UNITED STATES PATENT AND TRADEMARK OFFICE

APPLICATION NO.	FILING DATE	FIRST NAMED INVENTOR	ATTORNEY DOCKET NO.	CONFIRMATION NO.
10/674,198	09/29/2003	James Patrick Clinch	140/40652/O&T 975	2676

Office Action Summary

DETAILED ACTION

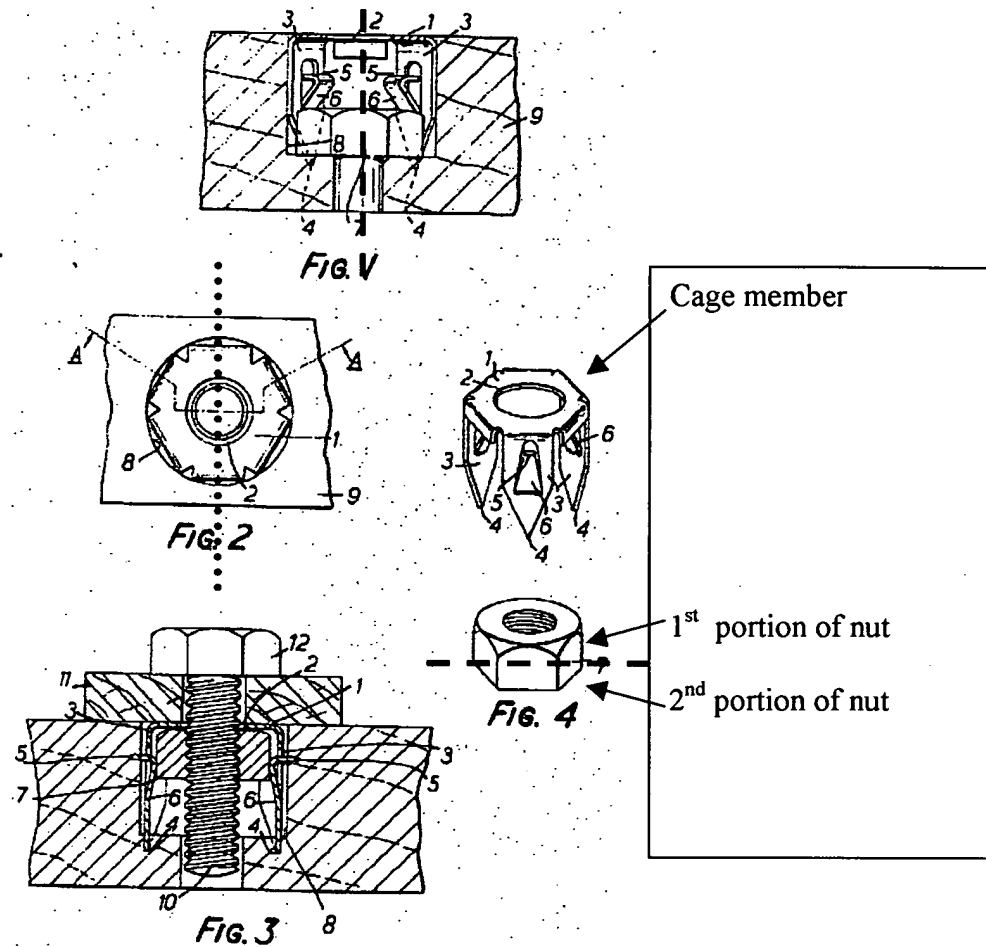
9. Claims 1-3,5-8,10-12,14-15, 19-20, are rejected under 35 U.S.C. 102(b) as being anticipated by Parkin USP 3451455.

Re claims 1 and 10: Parkin teaches a cage member (upper item in Fig 4) engageable with nut 7 having first and second portions and an aperture extending at least partially therethrough, (note that applicant is not claiming the nut, and a nut is capable of having distinct first and second portions. **However, further regarding claim 10**, the nut of Parkin can be considered to have a 1st portion [upper section in the figures, having the tapered sides] and a 2nd portion [lower section without taper]) thereby providing a cage nut assembly, said cage member comprising:

Said body defining a base portion (1) and at least one wall portion (3) and configured to engage the nut first portion such that the nut second portion does not come into contact with either the base or said at least one wall (Fig 1- notice that neither portion of the nut contacts the base or at least one wall, and in Fig 3, the 2nd portion does not contact the base or a wall 3), said body provides a limited range of nut movement in at least one dimension (axially along what could be called the bolt axis - see dashed line by examiner in Fig 1 above, although there is slight radial movement

Re claims 2-3, 5, 11-12,14: Said upper portion comprises at least one arm (6). Looking at Fig 2, note that there are at least two arm portions (6) which are positioned on opposite sides of a plane that bisects the base (see Fig 2 and examiner-drawn dotted line for plane), thus they are positioned opposite one another. The arms define an opening sized to receive the nut member therethrough when the nut 1st portion is engaged by said 2 arm portions (See Fig 3). Examiner notes that applicant did not require the arm to extend **directly** from said base.

Re claims 6,15: Fig 1 shows each arm 6 with a generally "C" shaped portion, and forming an opening between opposite arms.

Re claims 7,19: Looking at the difference in arm 6 between Fig 1 and Fig 3, it is clear that it is inherently flexible.

Re claims 8,20: As best understood, at least one arm portion can be moved (see Fig 1 and 3 comparison of arm for movement) to allow the 2nd portion of the nut member to be positioned above said base (entire nut is always above said base). Nut is between at least one wall portion of said body and something - an opposite wall.

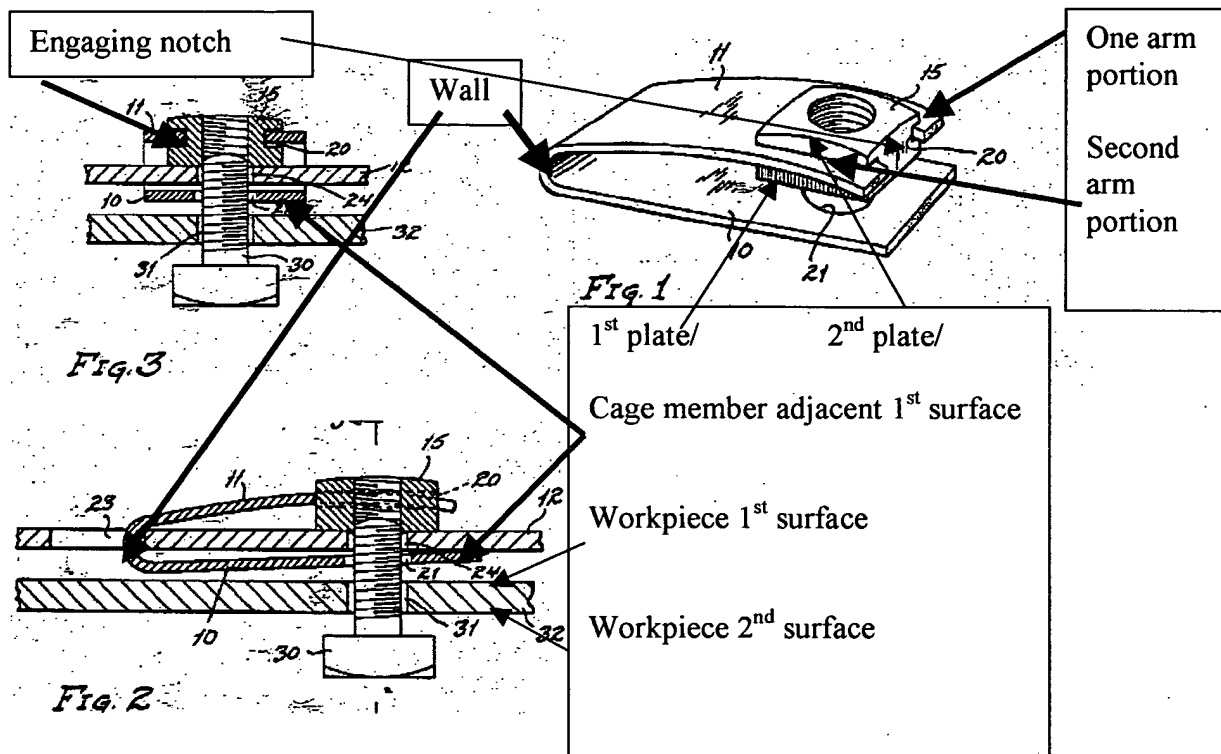
Re claims 1,2,3, 7,8,10,11,12,19,20: Tinnerman 342 in Figs 1-3 teaches a cage member and nut assembly, said nut (15) having a 1st and 2nd portion (see marked up

drawings below) enclosed by a cage member (10/11) which has a body configured to engage the nut member such that the nut member is encaged. The cage further comprises a body (11/10), and "11" is considered the upper cage/arm portion, and "10" is the base. The wall is labeled by examiner in drawings below. The nut engagement is such that the 2nd portion (same as the portion labeled "1st plate" below - looking at the drawings as oriented, it is the "lower" part of nut below "11") of the nut does not come into contact with either the base or the wall. Figs 1 and 3 shows a limited range of motion in at least one dimension. The body provides a limited range of nut movement in at least one dimension (axially along what could be called the bolt axis - although there is slight radial movement also).

Further Re claims 3 and 12: As shown in Fig 1, arm portion 11 forms two arm portions at the end as labeled by examiner in drawings below. These two arms are opposite each other.

Further Re claims 7 and 19: The at least one arm 11 is inherently flexible - see col 1 lines 41-42 and line 27, and line 36 - sheet metal that can be bent is inherently flexible.

Further Re claims 8 and 20: As best understood by examiner, the at least one arm 11 can be moved to allow nut 2nd portion to be positioned over base and between the wall and something - in this case the very end extension of the arm 11 past the notch.

Re claim 32,37: The body further comprises at least one wall (see label by examiner above), and Figs 1- 3 show the nut engaged such that the nut does not contact at least one wall.
